**CITY OF MANZANITA
PLANNING COMMISSION MEETING MINUTES
November 13, 2023**

NOTICE OF DESIGN REVIEW APPLICATION MANZANITA CITY HALL

Re: City Hall Project Plan Review

SUBJECT: Planning File 23029– City Hall Design Review

G1.01

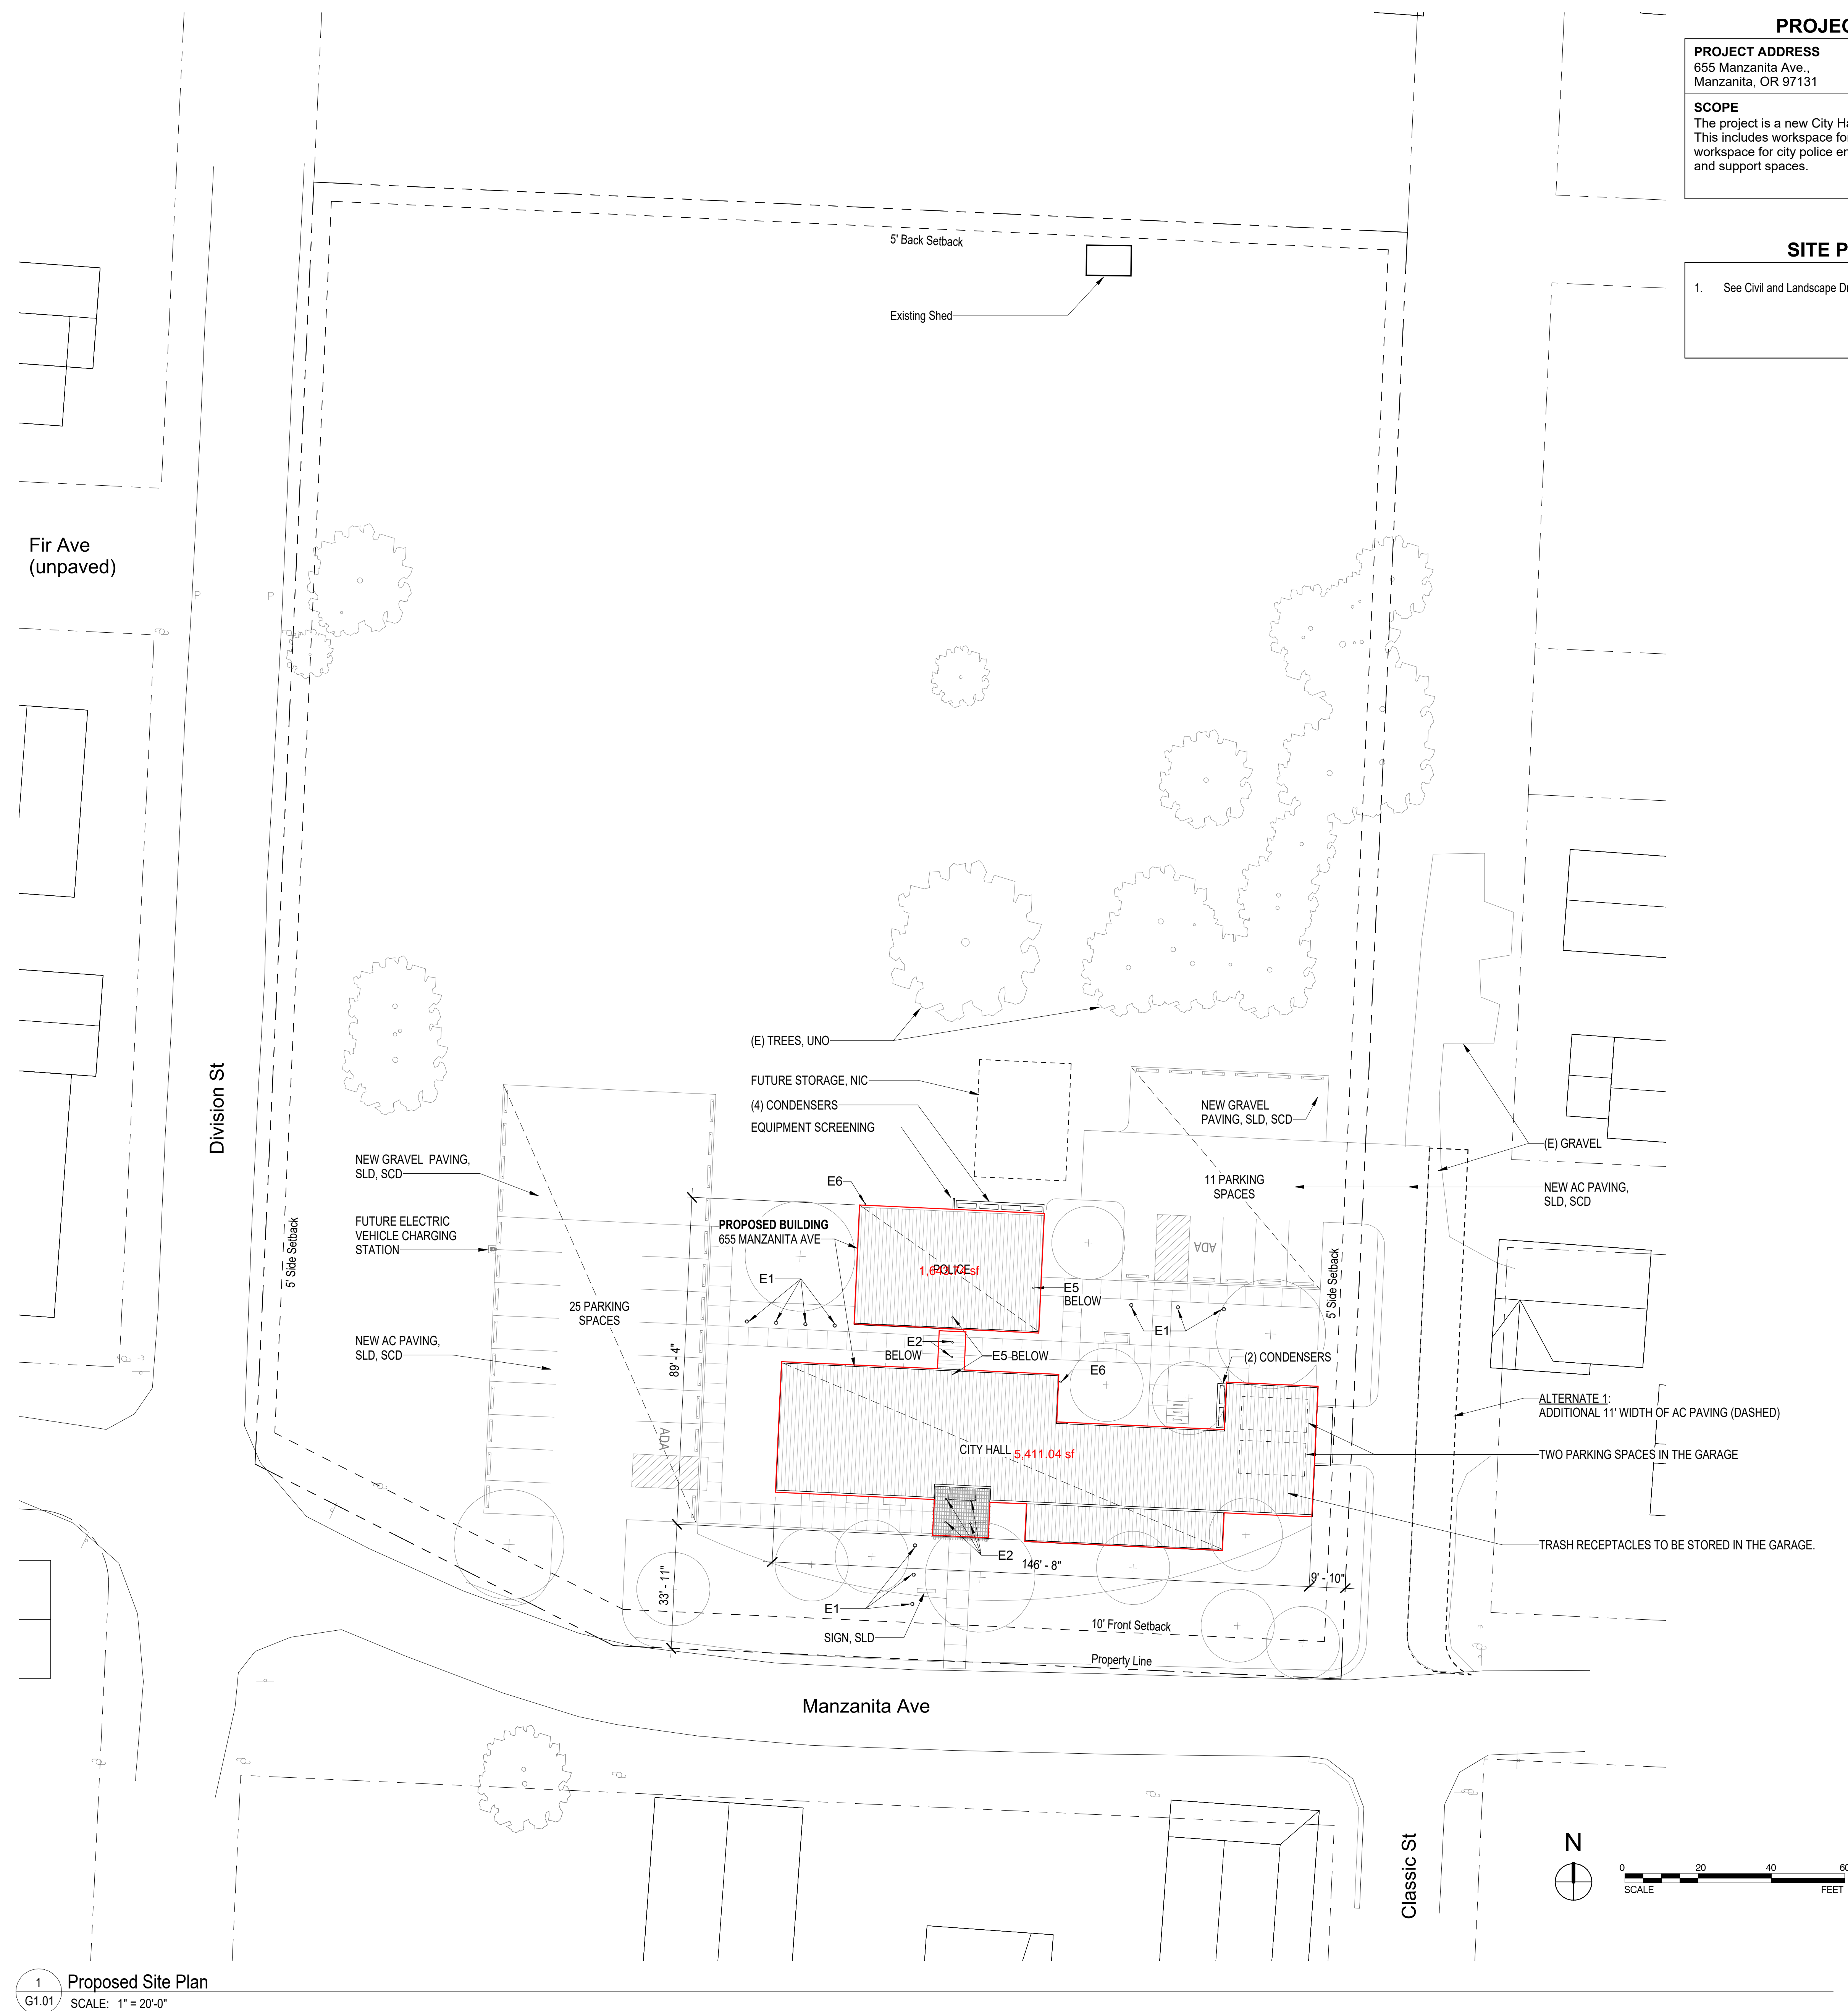
FINDINGS: This proposal does not include fencing on the west side of the southwest parking lot, which is adjacent to a residential use, therefore this requirement is not met. A letter describing Road Access issues of a proposed fence was received from the Fire Chief of Nehalem Bay Fire and Rescue, stating the fence could inhibit access in the event of an emergency. The applicant has proposed a solution to plant sight obscuring vegetation in lieu of a site obscuring fence. (231109 Letter – Fire Department, attached as exhibit A)

- A. The developer must demonstrate on construction documents, prior to issuance of building permits, site obscuring vegetation on the west boundary of the southwest parking lot. This site obscuring vegetation is intended to replace the fence to meet the screening requirement. At maturity, the vegetation shall be no less than 5' tall within the planting area.
